MILITARY SPECIFICATION
MICROCIRCUIT, DIGITAL, CMOS (INITIAL LOGIC)

This amendment forms a part of Military Specification MIL-M-63320A(AR) dated 8 April 1981, and is approved for use by the US Army Armament Research and Development Command and is available for use by all the Departments and Agencies of the Department of Defense.

FIGURE 1. Test Circuit for Leakage Current (Oscillator) and Oscillator Function tests.

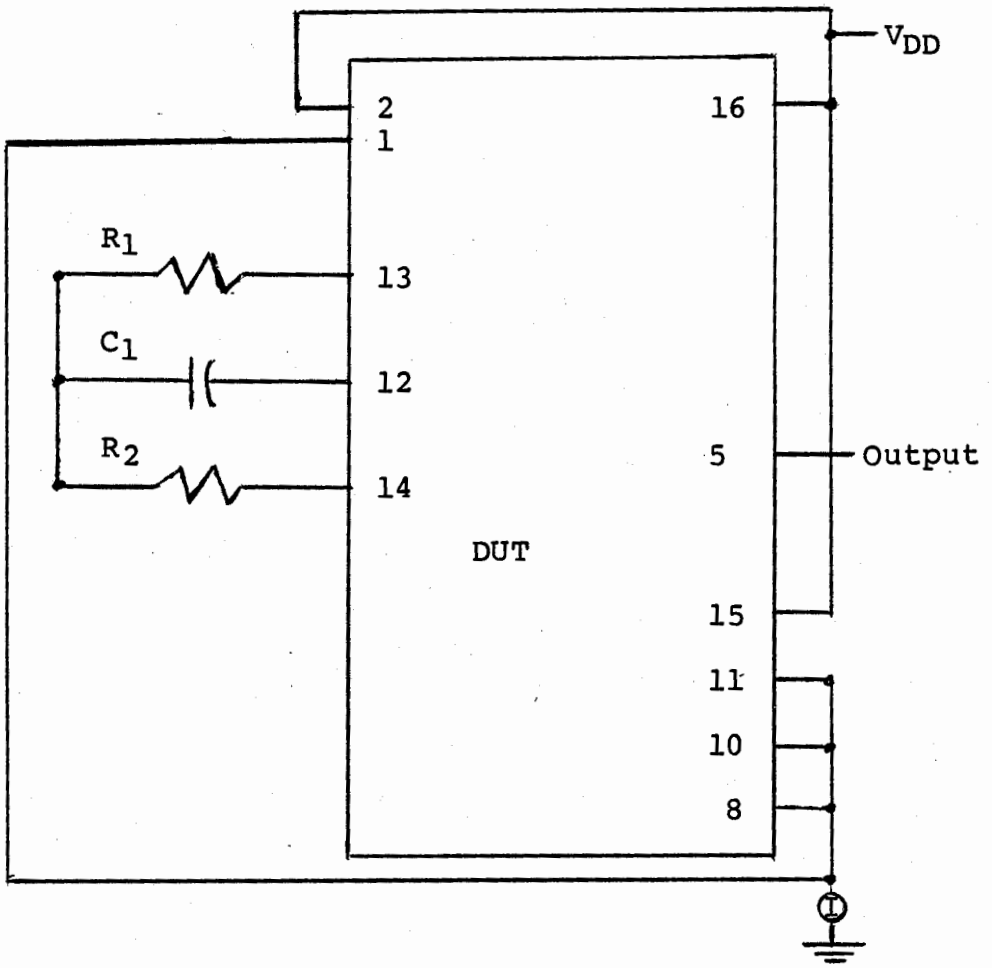
FIGURE 1: Delete present and substitute revised FIGURE 1 attached to this amendment.

FIGURE 15. Burn-in and Steady State Life-Test Circuit.

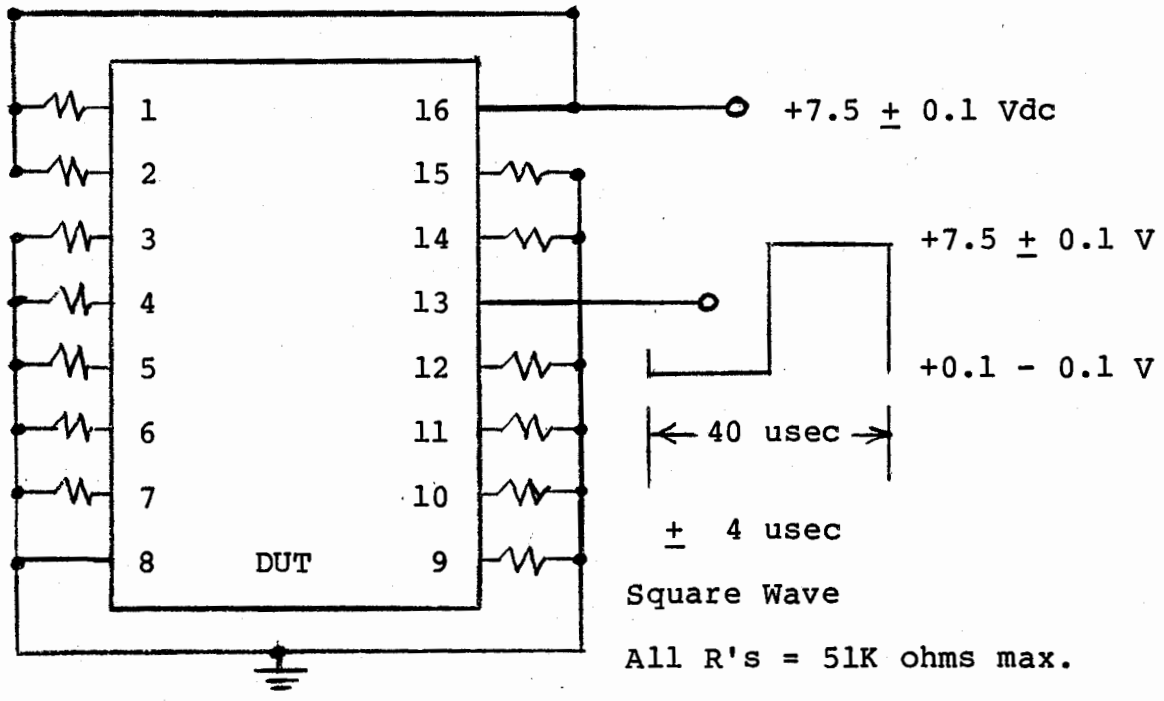
FIGURE 15: Delete present and substitute revised FIGURE 15 attached to this amendment.
